OPERABLE UNIT 1071

RESPONSE TO NOTICE OF DEFICIENCY

LOS ALAMOS NATIONAL LABORATORY

Re: RFI Work Plan for OU 1071
Los Alamos National Laboratory
NM0890010515

Data from "AVGAS SPILL TEST"

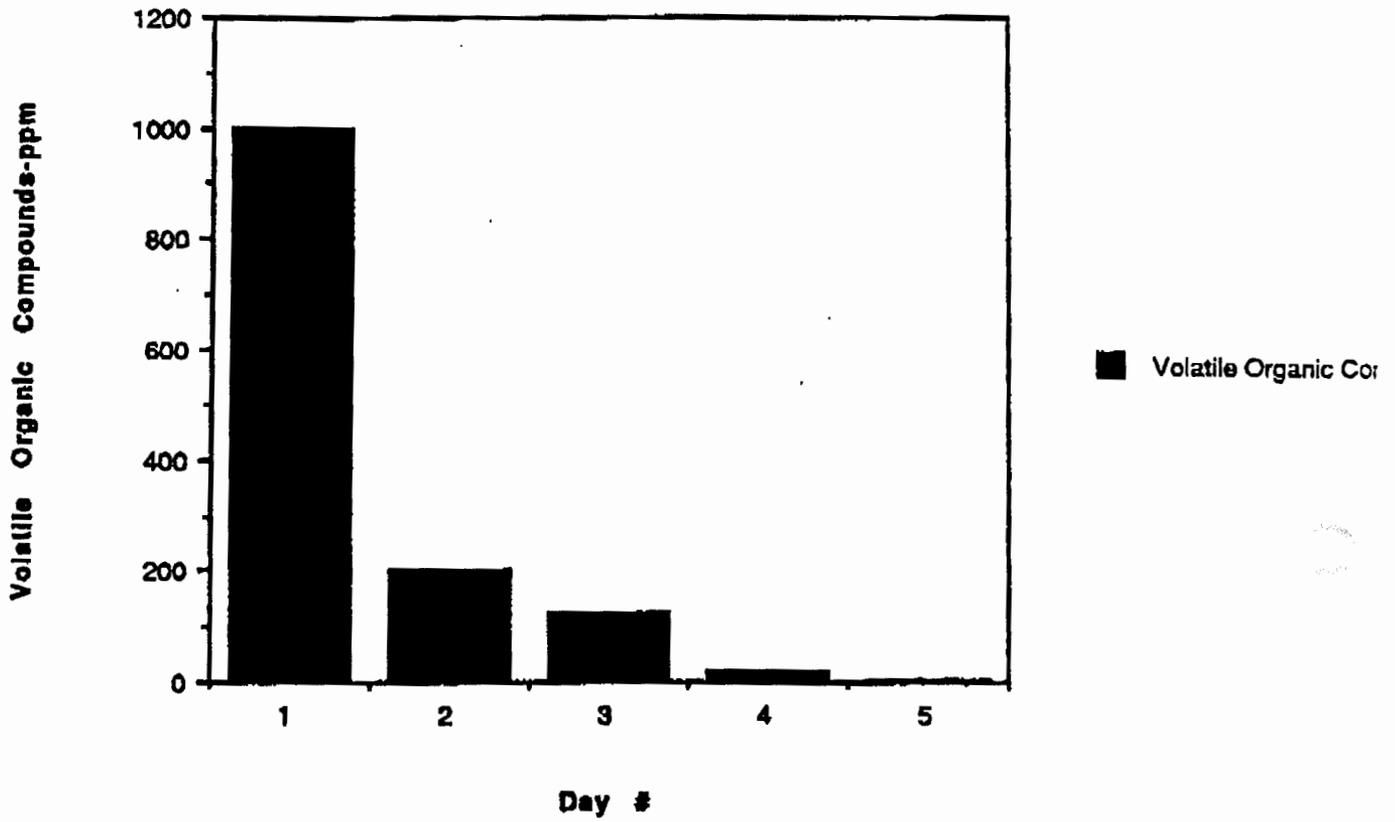
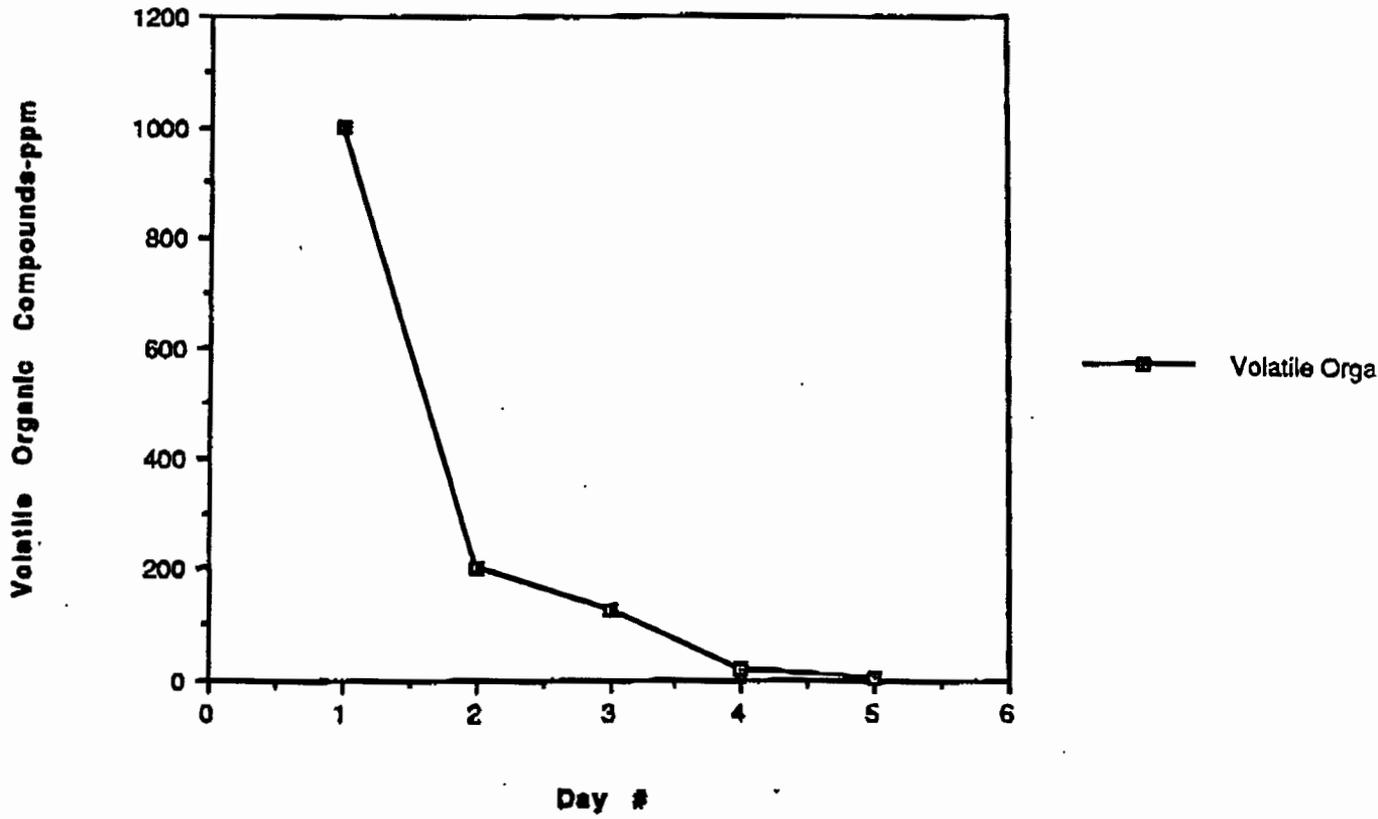
Comment: Areas of Concern C-74-001 and C-73-004 - provide some documentation of removal of tanks and any testing for contamination.

Areas of Concern C-73-001 through C-73-004 - Provide some documentation of removal of tanks and any testing for contamination.

were removed in the summer of 1992. No evidence was found that the tanks leaked. The ground was free of contamination. Previously, in April and May 1992, an 8 feet diameter area contaminated by about 5 gallons of Av-gas from an above-ground leaking valve was remediated. See Attachment D.

The pile of contaminated soils was about 8 cu. yds. in volume and measured 1000 ppm VOC's (PID) in the head space test. These results were confirmed by indicator tube results that showed 1000 ppm Aromatic Hydrocarbons.

Testing of the in-hole spill site after cleaning to consolidated Tuff indicated non detectable levels of VOC,s and Aromatic HC's. The Tuff was scraped clean and found to be un-fractured and well cemented.

On monday, May 4, Head Space tests of the previously spread soils were negative with respect to VOC's and AHC's. This data is displayed in the attached bar graph.
